DART SERVICE INSTRUCTION

TO AMEND INSTALLATION INSTRUCTIONS IIN-D412-702 REV. E
& INSTRUCTIONS FOR CONTINUED AIRWORTHINESS ICA-D412-702 REV. 3
REF TC STC SH04-7 & FAA STC SR01997NY

FIGURE 1. D412-702-051A/-051B/-052A/-052B INSTALLATION

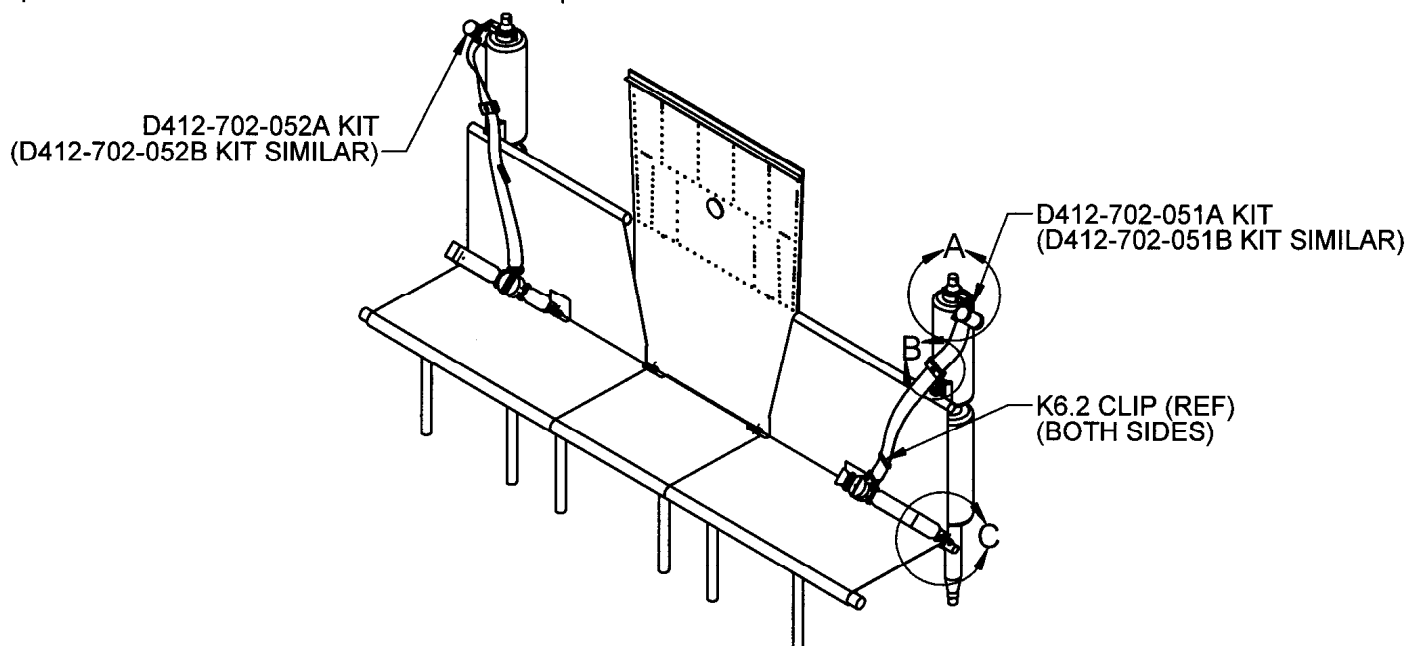
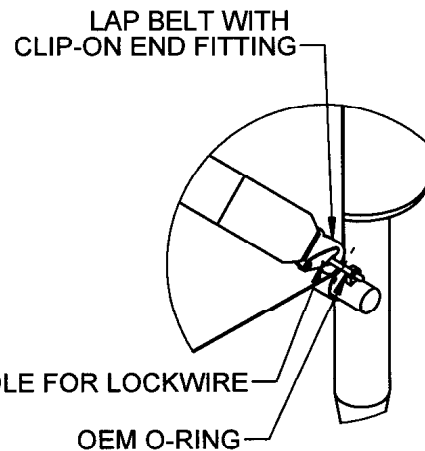
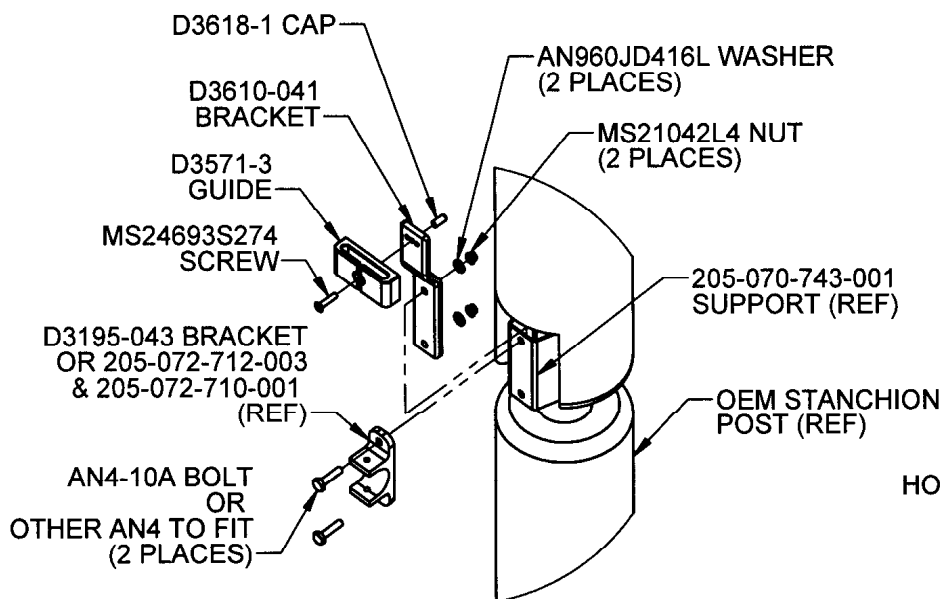
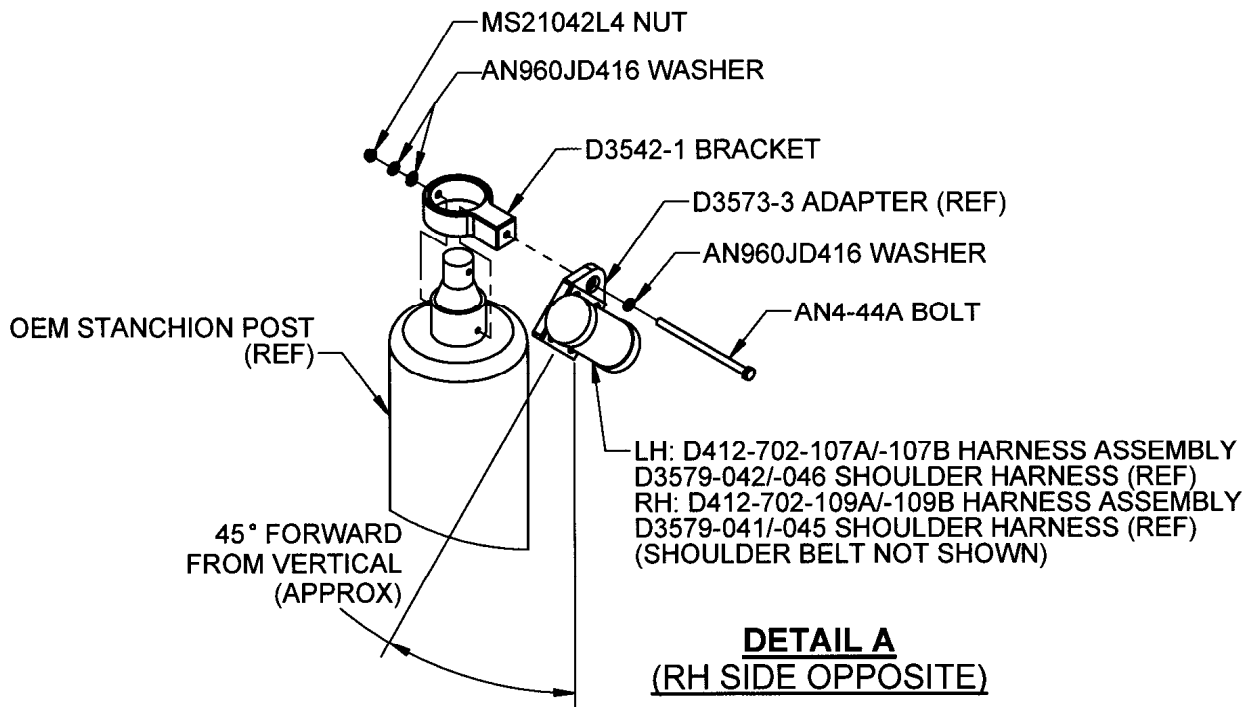
- 1) Remove existing lap belt and/or shoulder harness installations from the outboard seats of the 5-man forward facing bench per the applicable maintenance manual or ICA. If the Dart D412-702-011/-021/-013/-023 shoulder harness kits are already installed, do not remove the D3195-043 brackets from the stanchion posts. Refer to Detail B of *Figure 1*. Ensure that the D3268-1 placard is not removed from the aircraft.

- 3) Position a D3542-1 bracket over the top of each post as shown in *Figure 1, Detail A*. Install the D412-702-107A/-107B harness assembly on the bracket on the LH stanchion post at a forward angle of 45° using the hardware shown in *Detail A*. Install the D412-702-109A/-109B on the bracket on the RH stanchion post at a forward angle of 45°.

- 4) Remove the OEM 205-070-742-001 blocks from behind the OEM 205-070-743-001 supports and discard the fasteners. Install the D3610-041 bracket and D3571-3 guide with the D3618-1 cap on each post as shown in *Detail B*. Trim the D3618-1 cap as needed to fit. Torque the AN4 bolts to 50-70 in-lbs (5.6-7.9 N-m).

- 5) Feed the shoulder belts through the guides so that the K6.2 clips are between the guides and the buckles as shown in *Figure 1*. Clip the lap belts and buckles onto the OEM seat belt rings as shown in *Detail C* and engage the belts in the buckles. Orient the harness assemblies and the D3571 guides so that the shoulder belts have a straight path to the buckles as shown in *Figure 1*. Torque the #10 fasteners to 20-25 in-lbs (2.3-2.8 N-m). Ensure that the that the D3569-1/-2/-3 decals on the buckles face outward.
